## **NEW SAFETY RECALL SERVICE BULLETIN 386**

**ROCKET III IDLE QUALITY - S/B 386**

# Recall Action Notice

**Subject** ..... **Poor Idle Quality/Engine Stalling**

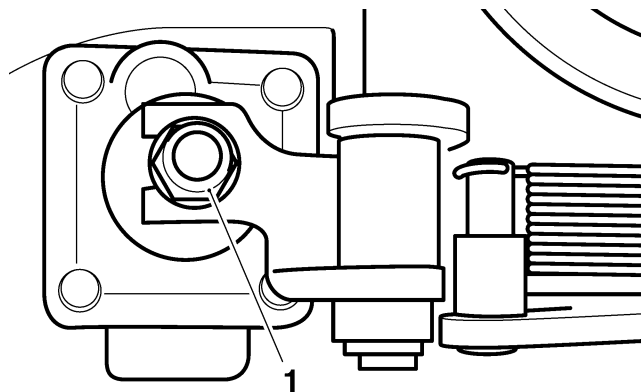
14. The voltage reading on the tool should now be 0.12 volts higher than the reading noted in the previous step. If the reading differs, adjust the nut on the stepper arm until the correct reading is reached.
- **For Example: Initial voltage = 0.60 + 0.12 = 0.72volts with the stepper fully open.**
